Administrative Approval Action

Case File / Name: SUB-0061-2023
DSLCL - GRANT AVENUE TOWNHOMES

REQUEST: Development of a 2.28 acre/99,267 sf tract zoned R-6. A proposed 27-lot development of 26 townhome lots and 1 Common Area Lot with Open Space. The proposed subdivision is a Compact Development per UDO Sec.2.3.1. Site development includes 1,135 sf of right-of-way dedication, leaving a net area of 2.25 acres/98,132 sf.

PRELIMINARY COMPACT SUBDIVISION SUB-0061-2023

Tree Conservation Plan Data Sheet
 UDD Article 9.1 Tree Conservation
 (Includes applicable information on the plan sheet)

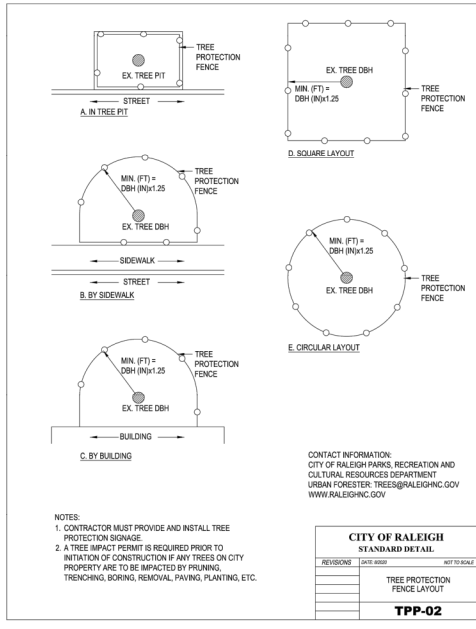
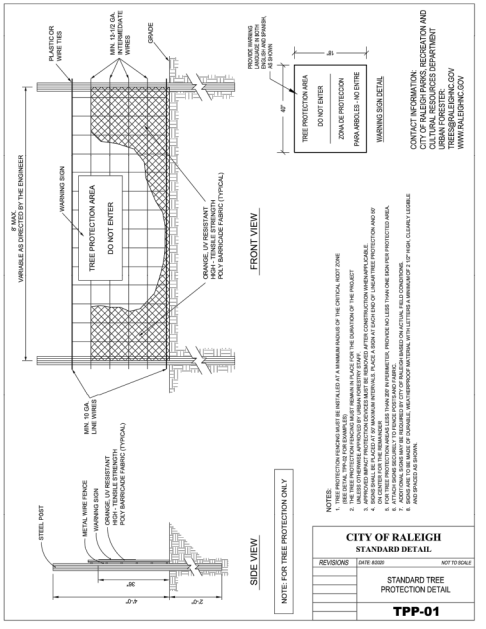
9. Please address this prior to SPR as the change occurred on the final review of the preliminary plan review: Tree protection fence and LOD is now shown behind Zone 2 where the OHP lines and existing fence are. This is not permissible as these two features, the fence and OHP lines, must be removed by hand without disturbance to Zone 2. Place tree protection fence along Neuse Riparian Buffer Zone 2 as was shown in these two areas on submittal two. Remove the proposed trees in these areas as they are not needed (currently shown on the Tree Conservation Plan sheet and Planting Plan sheet).
10. Submit a final tree conservation plan that includes metes and bounds descriptions of all tree conservation areas and tree protection fencing as required (UDO 9.1.5).
11. Tree protection fence must be inspected by Urban Forestry staff prior to the issuance of a grading permit.

SHEET TITLE:
PLANTING PLAN

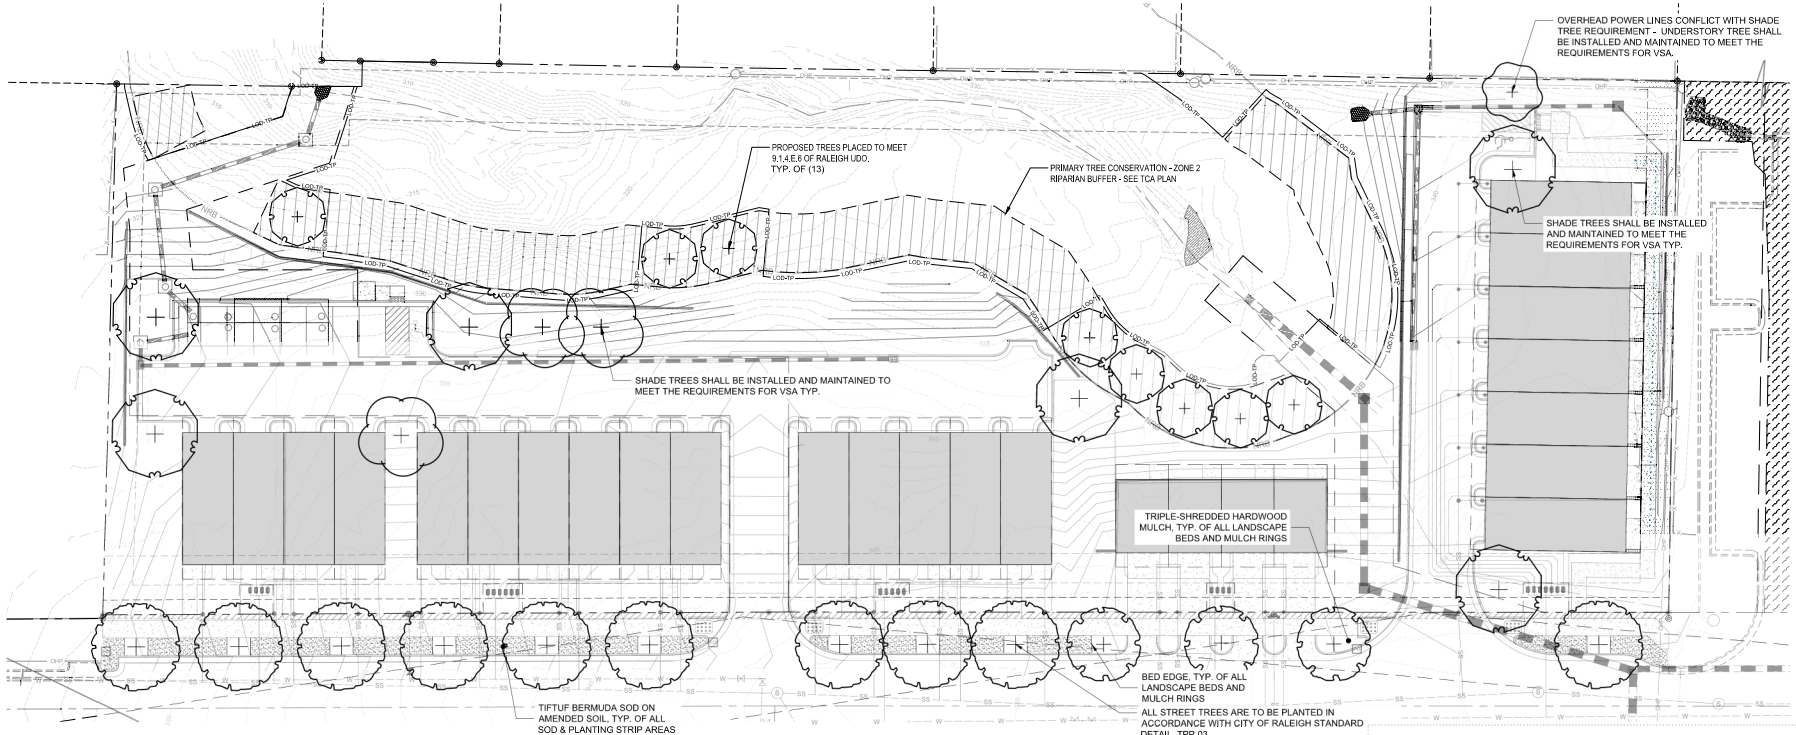
2. Prior to Site Permitting Review (SPR) approval, landscape plan shall show the following trees have been replaced with shade trees allowed by the Design & Installation standards (UDO Sec. 7.2.7.C). Specifically, Pistacia chinensis 'Keith Davey' / Keith Davey Chinese Pistache.
